ADV7181D DDR Timing Specification Update

► DDR Timing Specification that will be in ADV7181D Datasheet Rev. B

Figure 5. Pixel Port and Control DDR Output Timing (CP Core)

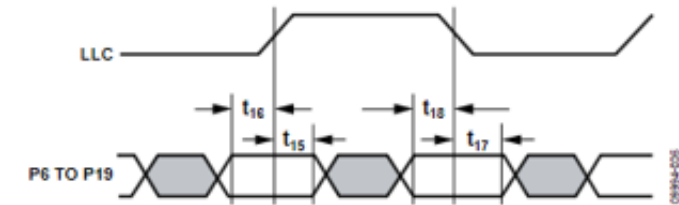
Parameter ¹	Symbol	Description	Min	Typ	Max	Unit
DDR (CP) ^{4,5}	t ₁₅	Positive clock edge to end of valid data	$-4 + T_{LLC}/4$			ns
	t ₁₆	Positive clock edge to start of valid data	$0.25 + T_{LLC}/4$			ns
	t ₁₇	Negative clock edge to end of valid data	$-2.95 + T_{LLC}/4$			ns
	t ₁₈	Negative clock edge to start of valid data	$-0.5 + T_{LLC}/4$			ns

⁴ CP timing figures obtained using maximum drive strength value (0xFF) in Register Subaddress 0xF4.

⁵ DDR timing specifications dependent on LLC output pixel clock; $T_{LLC}/4 = 9.25$ ns at LLC = 27 MHz.

Figure 5. Pixel Port and Control DDR Output Timing (CP Core)

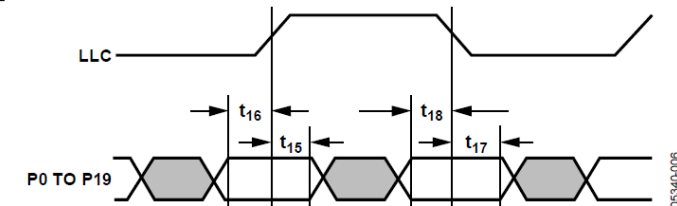
Parameter ^{1,2}	Symbol	Test Conditions	Min	Typ	Max	Unit
Data Output Transition Time DDR (CP) ^{5,6}	t ₁₅	Positive clock edge to end of valid data	1.9			ns
Data Output Transition Time DDR (CP) ^{5,6}	t ₁₆	Start of valid data to positive clock edge	1.7			ns
Data Output Transition Time DDR (CP) ^{5,6}	t ₁₇	Negative clock edge to end of valid data	1.4			ns
Data Output Transition Time DDR (CP) ^{5,6}	t ₁₈	Start of valid data to negative clock edge	1.7			ns

⁵ CP timing figures obtained using maximum drive strength value (0x3F) in Register Subaddress 0xF4.

⁶ Guaranteed by characterization up to 75 MHz pixel clock.
